Yates Drilling Company Cactus Queen Unit #09 Unit G, Section 34-12S-31E Chaves County, NM 30-005-20972 Sundry attachment April 8, 2009

CACTUS QUEEN UNIT #9

Permanent Abandonment of Federal Wells Conditions of Approval

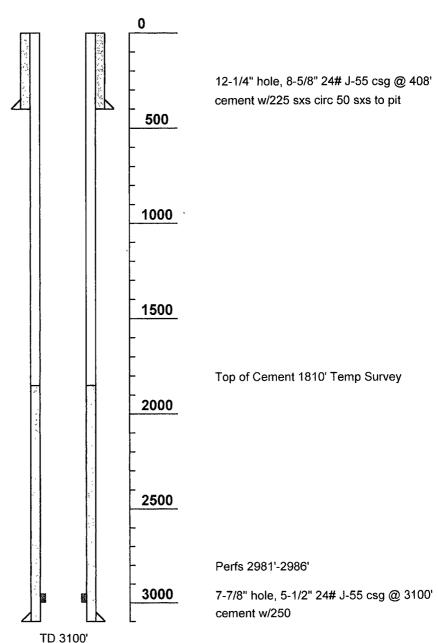
* Spot 25 sx. cut. @ 2150', BOS.
